Re: Comments on Environmental Assessment for Scotts Valley Casino and  
Tribal Housing Project

This letter and its attachments and enclosures provide comments from the Yocha Dehe Wintun Nation on the Environmental Assessment ("EA") prepared for the Scotts Valley Casino and Tribal Housing Project ("Project").

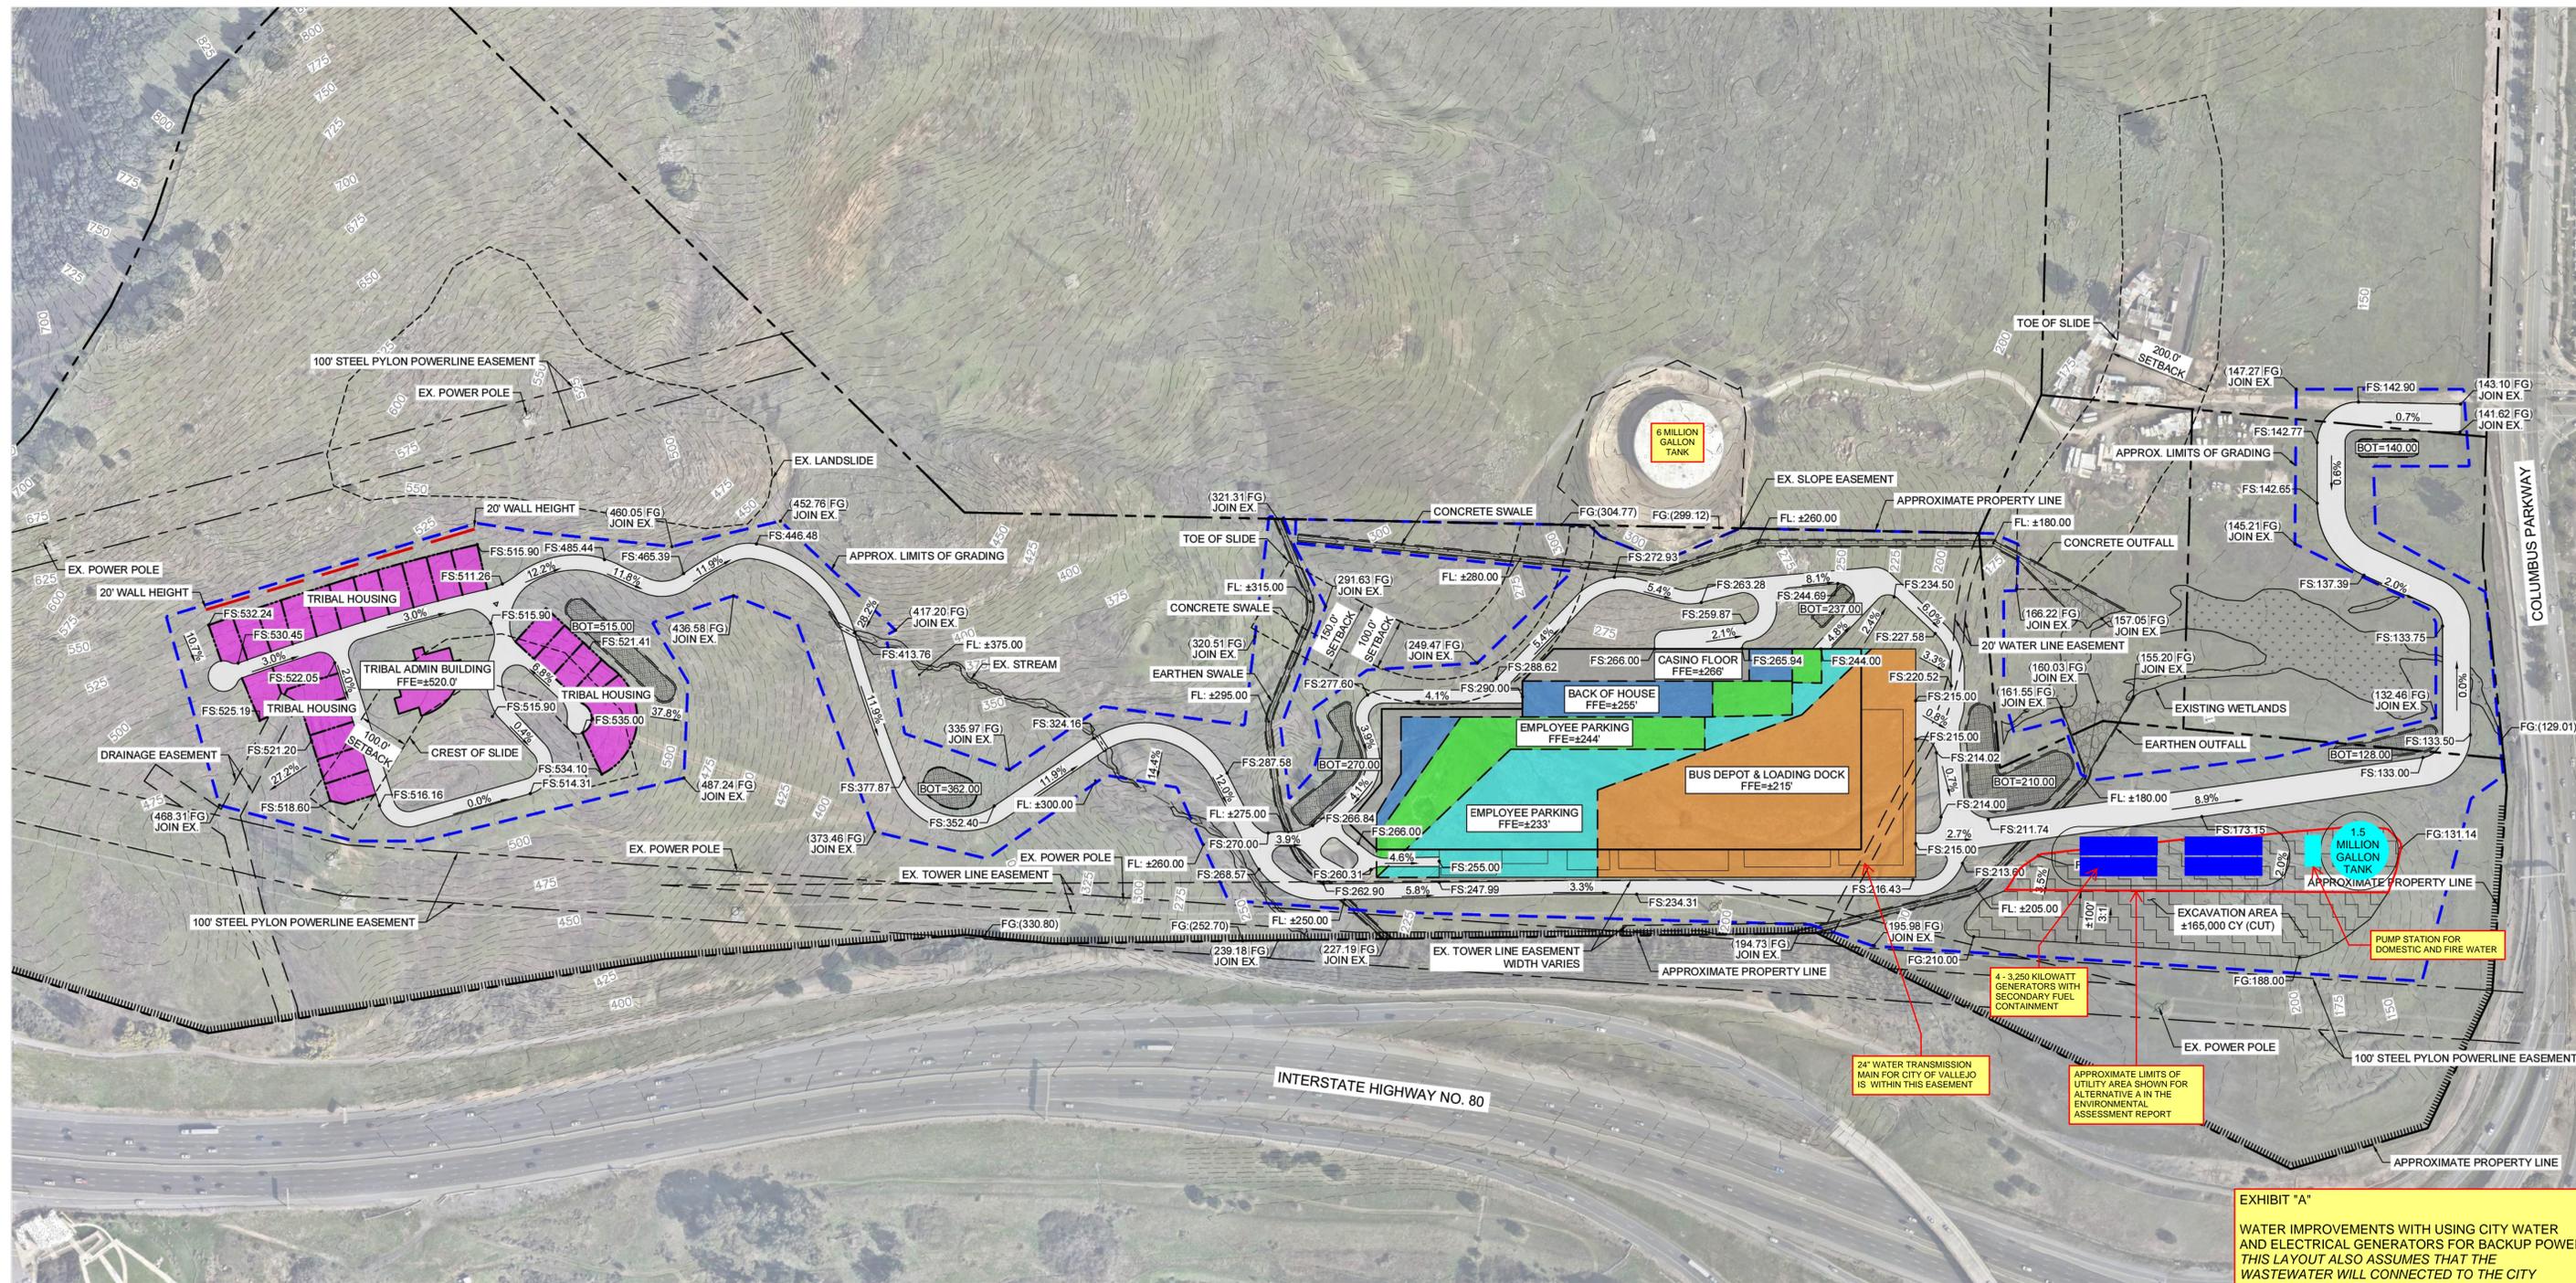
- **Exhibit “A”** shows the layout of the 1.5-million-gallon tank specified in the EA, along with four 3,250 kilowatt generators that would be needed for backup power. Figure 4.3 of Appendix B of the EA shows a 112-foot diameter for the 1.5-million-gallon tank and that dimension was used to plot this tank. The footprint of the generators along with secondary containment was taken from standard sizing for this equipment and experience with the recent installation of a 3,000-kilowatt generator. As can be seen the utility area as designed is not large enough for both utilities. Once the grades are flattened in the utility area the useable area will more than likely get even smaller to accommodate transition grading. Retaining walls or 2:1 slopes may be required in order to obtain the usable area necessary. Another consideration for the utility area is the turning movements of the large vehicles that will be needed to construct these facilities as well as maintain them – particularly given the difference in grade between the access road and the utility area that is shown in the EA. Once these turning movements are factored in, the useable area will be dramatically reduced.

**EXHIBIT "B"**  
 WATER IMPROVEMENTS WITH USING ONSITE GROUNDWATER AND ELECTRICAL GENERATORS FOR BACKUP POWER  
 THIS LAYOUT ALSO ASSUMES THAT THE WASTEWATER WILL CONNECTED TO THE CITY SYSTEM

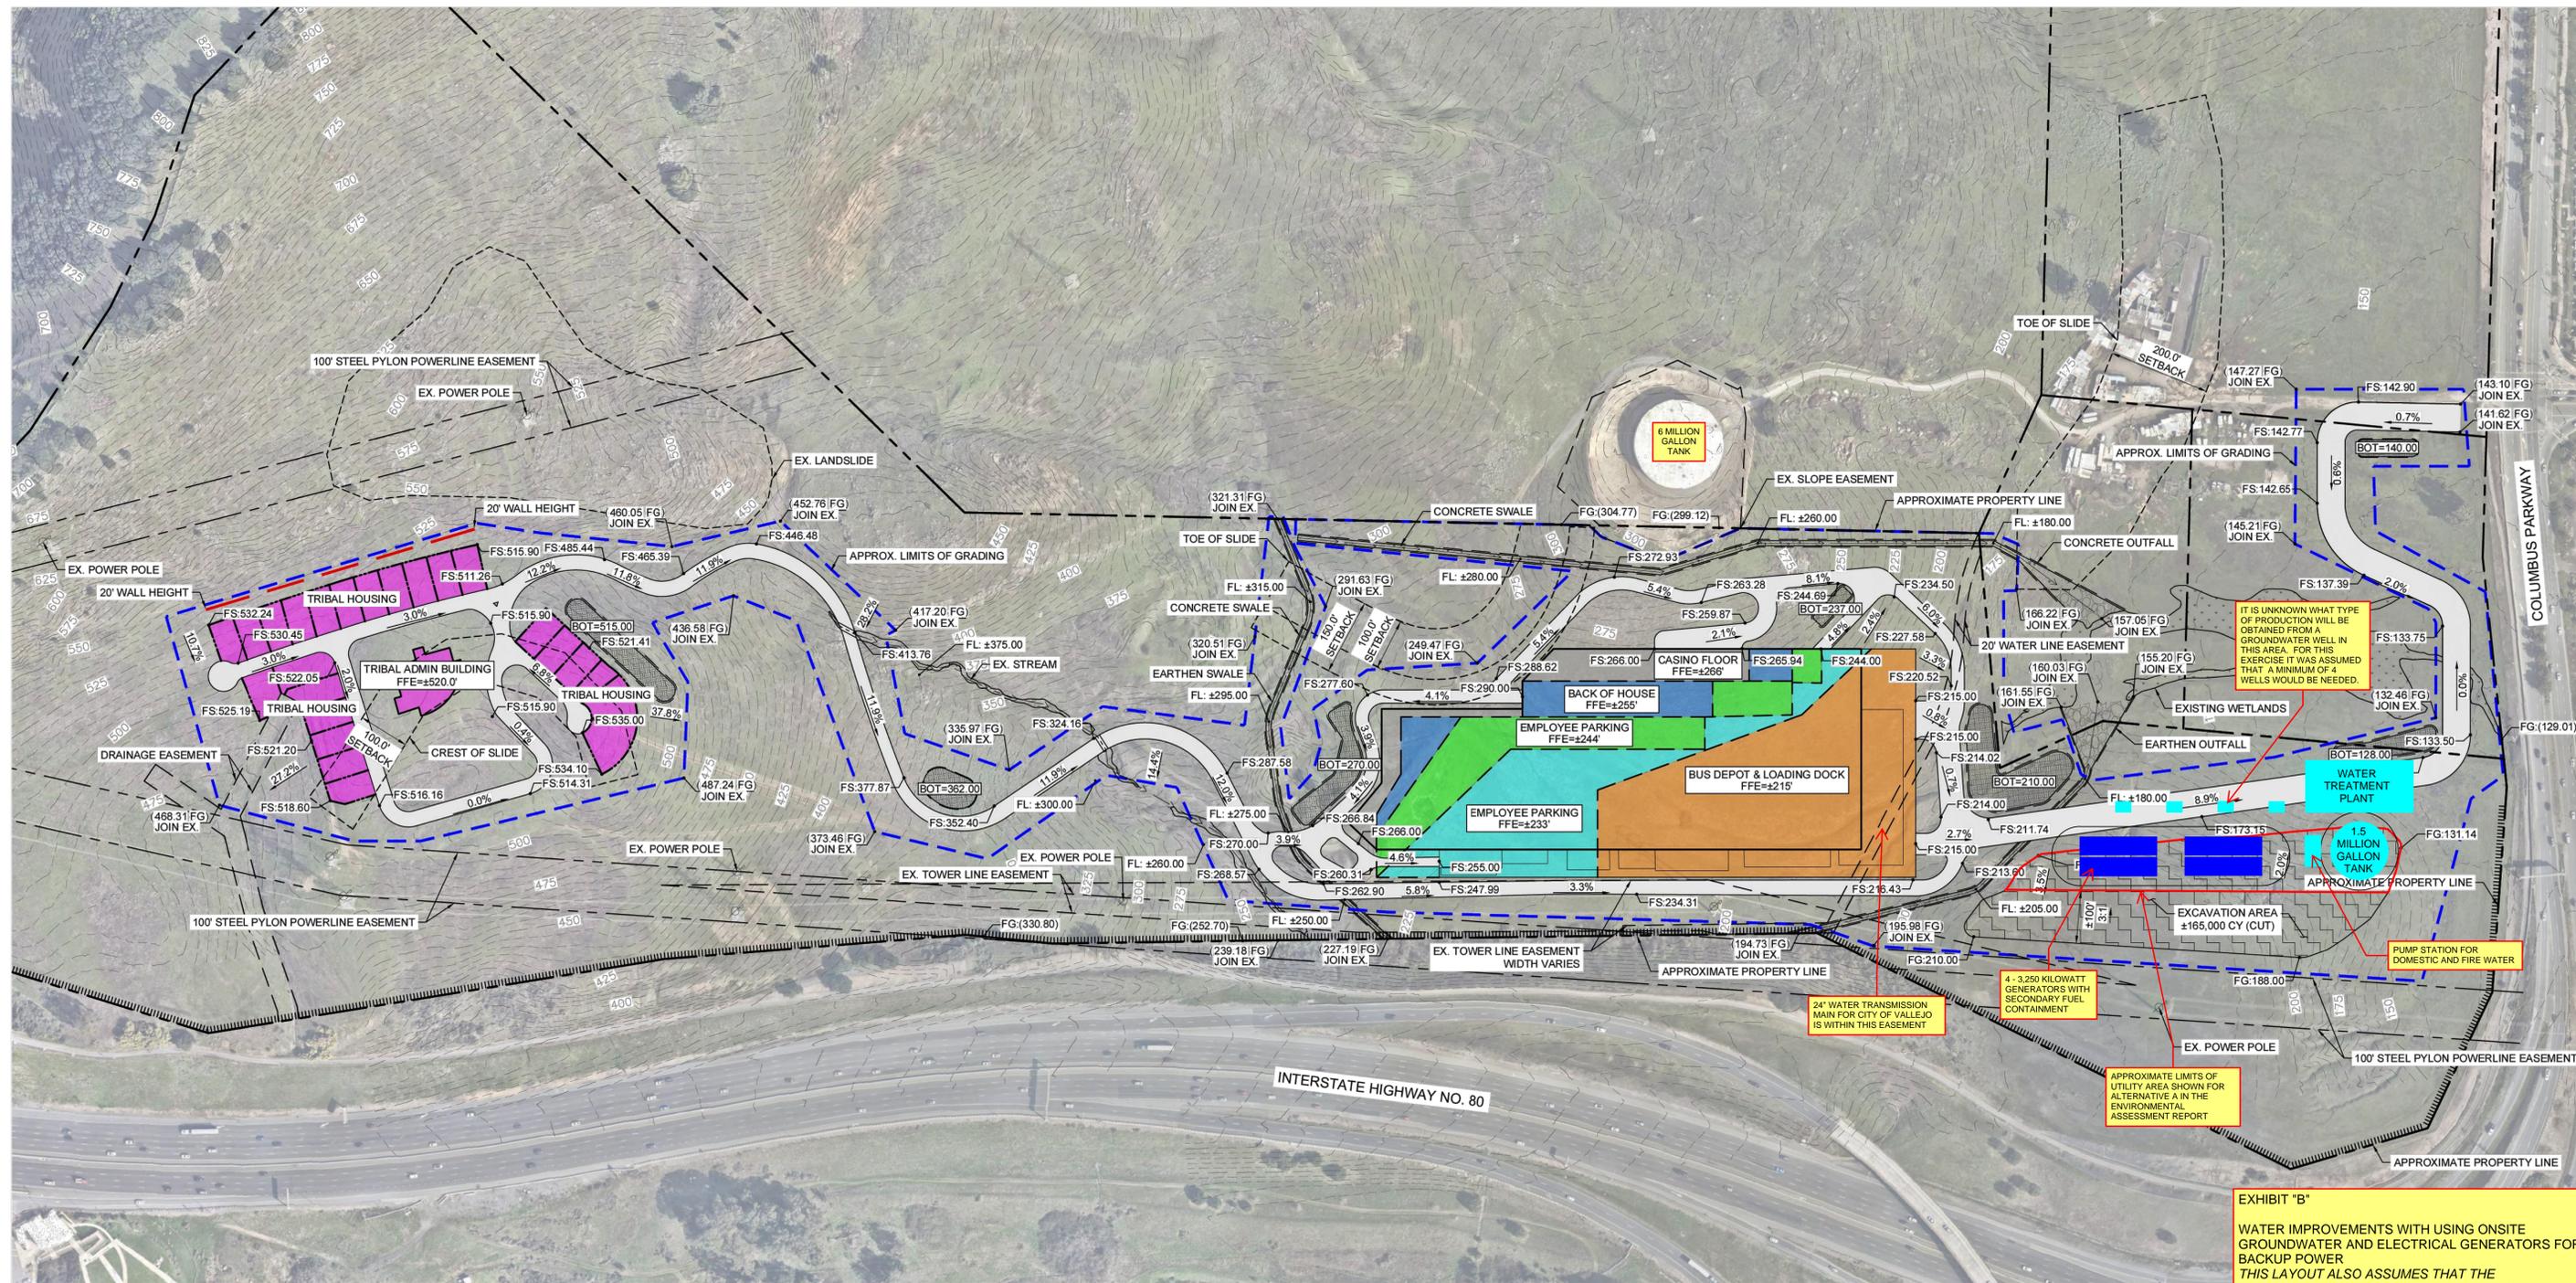
- **Exhibit “B”** shows the layout of the 1.5-million-gallon tank, the four 3,250-kilowatt generators, the water treatment plant and 4 well sites. Figure 4.3 of Appendix B of the EA shows a 112-foot diameter for the 1.5-million-gallon tank and that dimension was used to plot this tank. The footprint of the generators along with secondary containment was taken from standard sizing for this equipment and experience with the recent installation of a 3,000-kilowatt generator. The water treatment plant was plotted with a 0.5-acre footprint per Figure 5-11 of Appendix B. The well sites were shown as 20 feet x 30 feet per Section 4.1.1 of Appendix B of the EA at 100 feet spacing. For this layout the utility area would need to be at least two times the area shown in the EA to contain all these improvements. After factoring in the turning movements for the large vehicles necessary to install and maintain these facilities, the footprint for the utility area would need to expand still further beyond what is shown. The design of these facilities as shown is not feasible.

**EXHIBIT "C"**  
 WATER IMPROVEMENTS USING ONSITE GROUNDWATER, ELECTRICAL GENERATORS FOR BACKUP POWER, WASTEWATER TREATMENT PLANT AND TANKS FOR RECYCLED WATER STORAGE

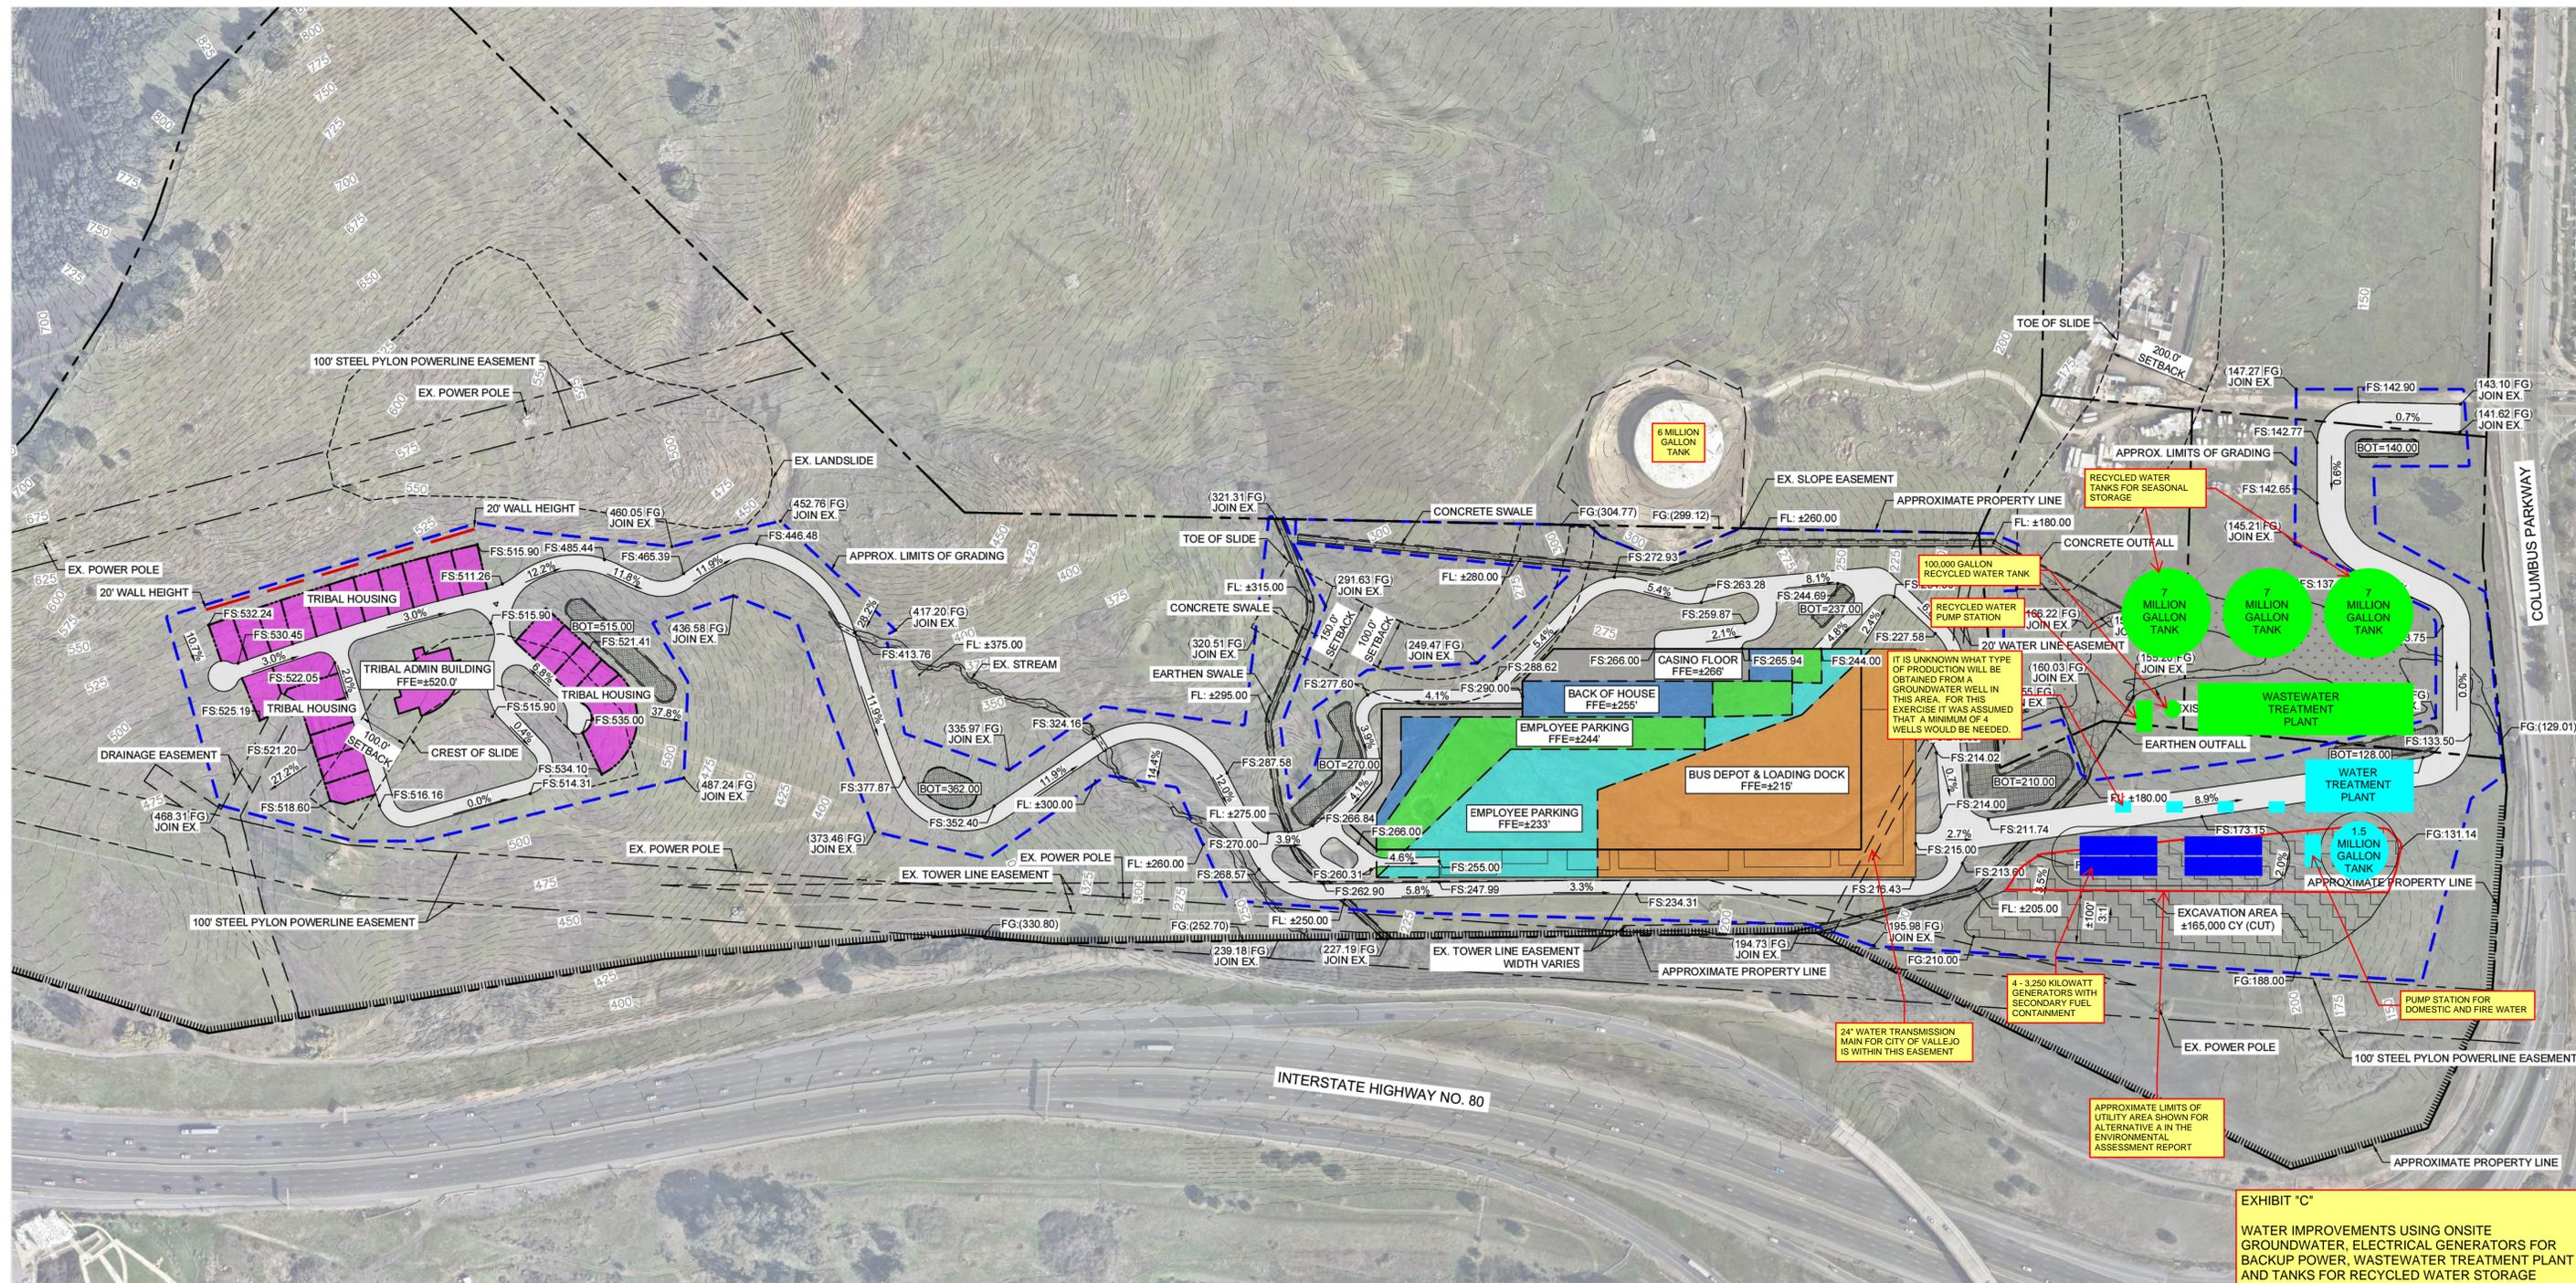
- **Exhibit "C"** shows the utility layout with onsite water and wastewater treatment. Figure 4.3 of Appendix B of the EA shows a 112-foot diameter for the 1.5-million-gallon water storage tank and that dimension was used to plot this tank. The footprint of the generators along with secondary containment was taken from standard sizing for this equipment and experience with the recent installation of a 3,000-kilowatt generator. The water treatment plant was plotted with a 0.5-acre footprint per Figure 5-11 of Appendix B of the EA. The well sites were shown as 20 feet x 30 feet per Section 4.1.1 of Appendix B of the EA at 100 feet spacing. The wastewater treatment plant was plotted with a 1.0-acre footprint per Figure 5-11. The 100,000-gallon recycled water tank is shown with a 32-foot diameter per Table 5-6 and the 7-million-gallon tanks are shown with a 173-foot diameter per Table 5-9. For this layout the utility area would need to be substantially larger, about five times the area shown in the EA to contain all these improvements. After factoring in turning movements for the large vehicles are established to install and maintain these facilities, the footprint for the utility area would need to expand still further from what is shown. It does not appear that this would be a viable option based on the available space shown in the Exhibit for Alternative A.
